Project Name: Panera
 Description: Final site plan approval and PDA recommendation
 Date on Agenda this packet pertains to: January 16, 2025

RE: Panera Bread and Retail Development- Preliminary Site Plan Review – 4th Review

RE: Panera Bread
Preliminary Site Plan – Review #3

SAI # 240492
DRAWING NUMBER: **P-01**

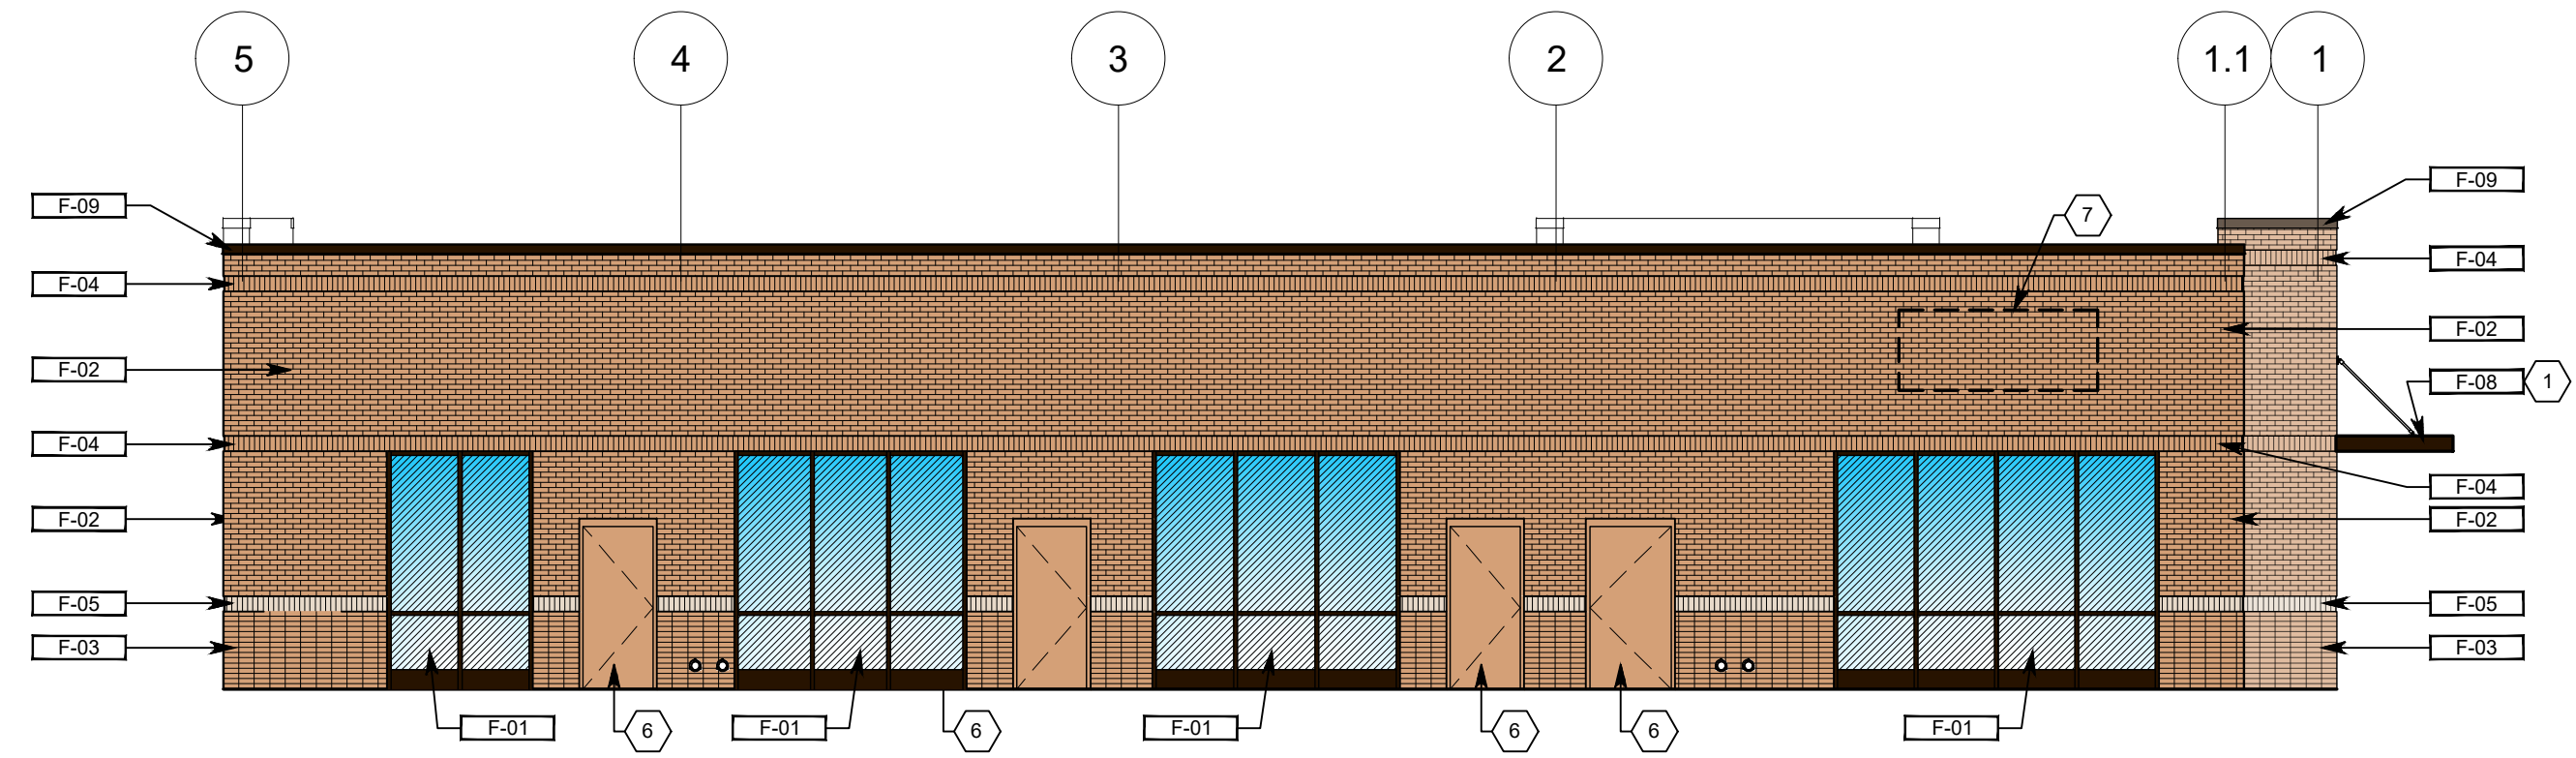
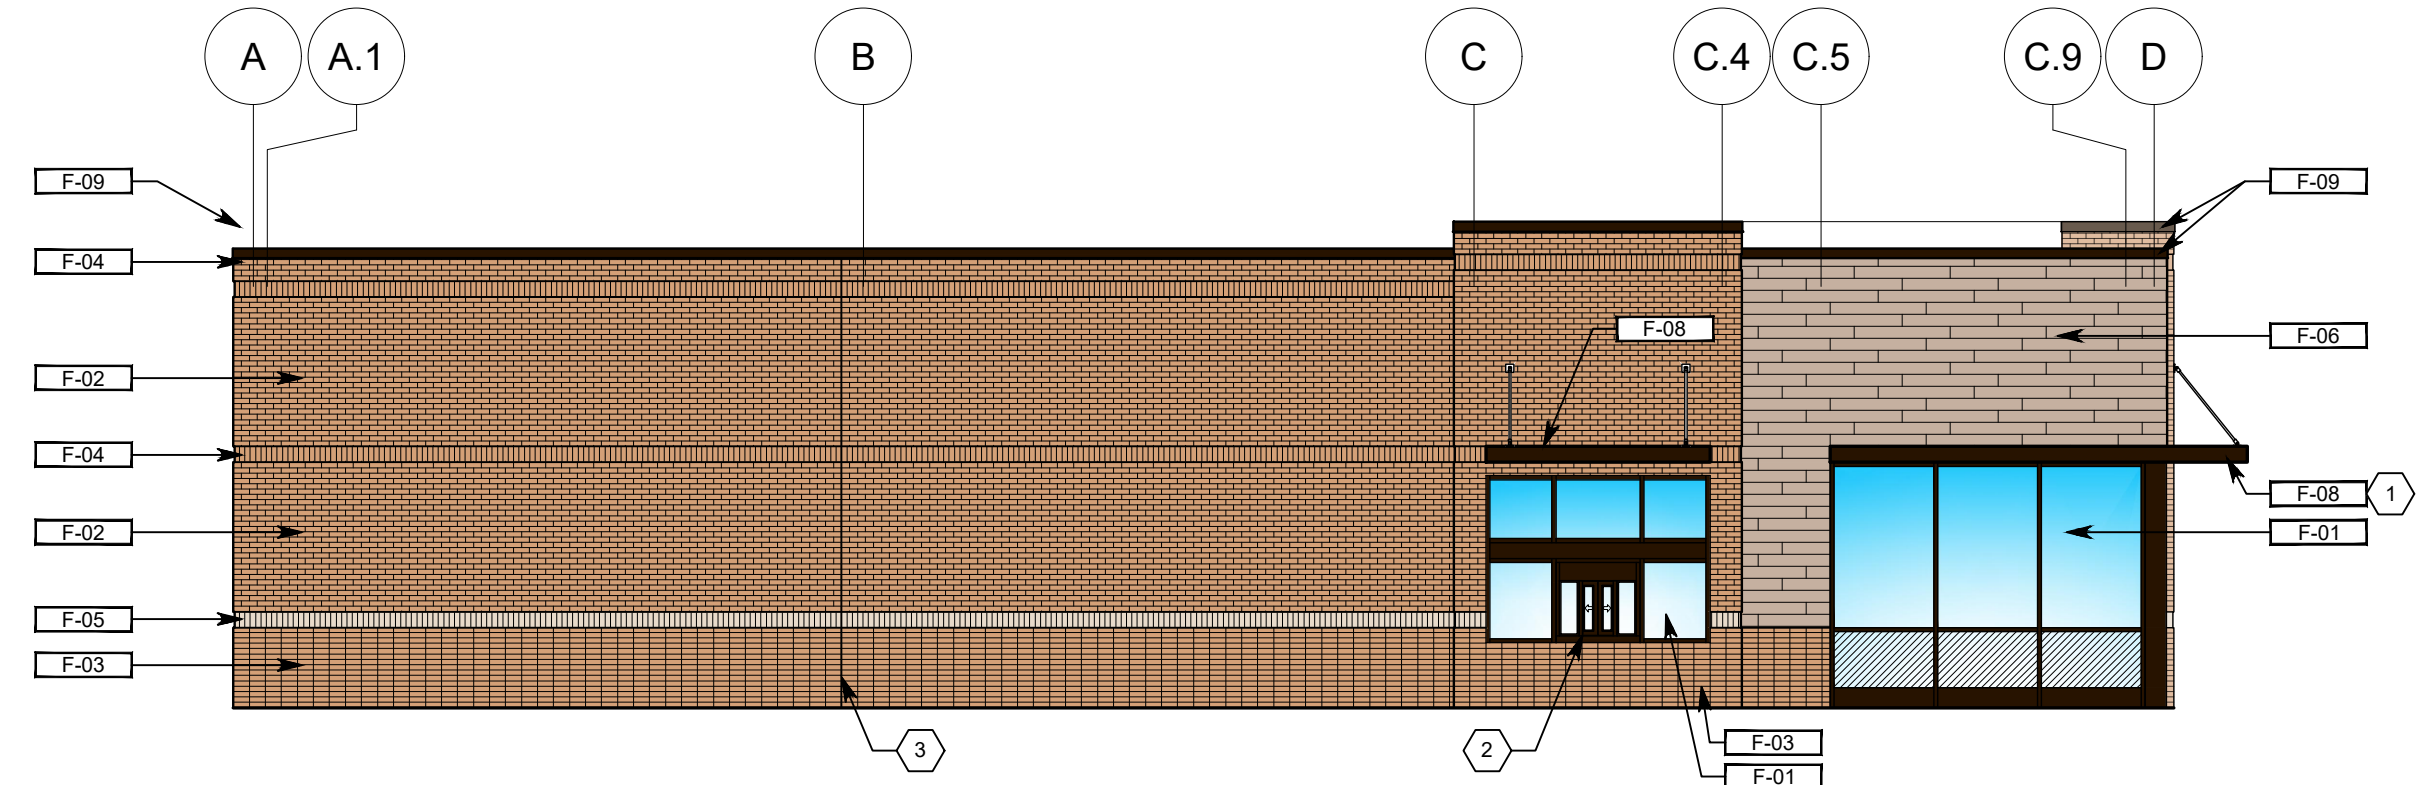
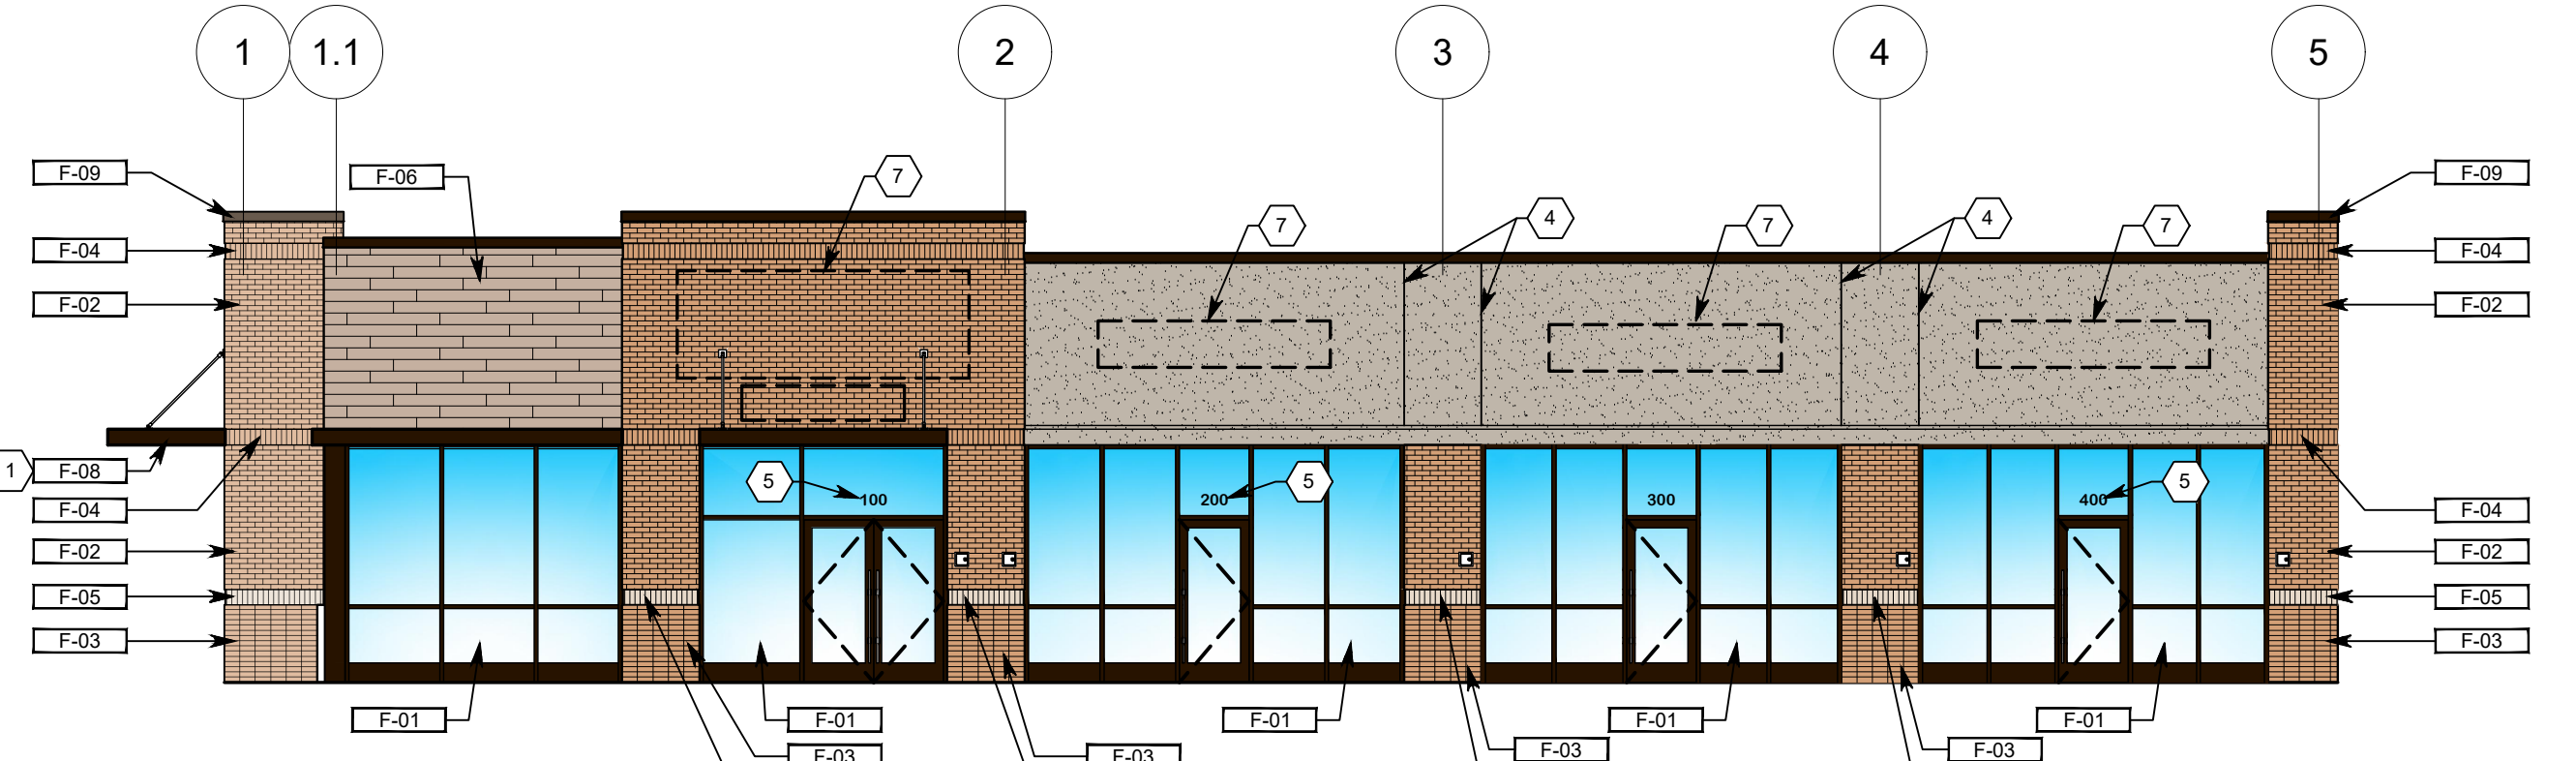
New renderings showing the elevations for the four (4) tenant building are provided on Sheet P-01. Front façade design elements have been incorporated into the North elevation via the use of spandrel glass. We note the functionality of this space is the rear of the building and traffic utilizing Bogie Lake Road is for the purpose of accessing other outlets or Meijer. For this reason, we are agreeable to allowing the removal of spandrel glass in lieu of foundation landscaping that screens all mechanical equipment and utilities infrastructure along the northern elevation.

All buildings shall have windows at eye level covering at least 30 percent of the front facade (north and south elevations of the building). The building elevations shall be revised to provide the required windows, and a window coverage calculation shall be provided on the building elevations. **(Comments addressed. The north and south facades now contain the required window coverage, and such coverage has been noted on the exterior elevations).** (Comment outstanding. Window coverage percentages should be added to Sheet P-01 for south elevation and north elevation (pending comment above)).

The revised four tenant structure is shown on Sheet P-01. Placeholders for wall signs are shown on the south and north elevations. Signage is reviewed and approved administratively by the Township.
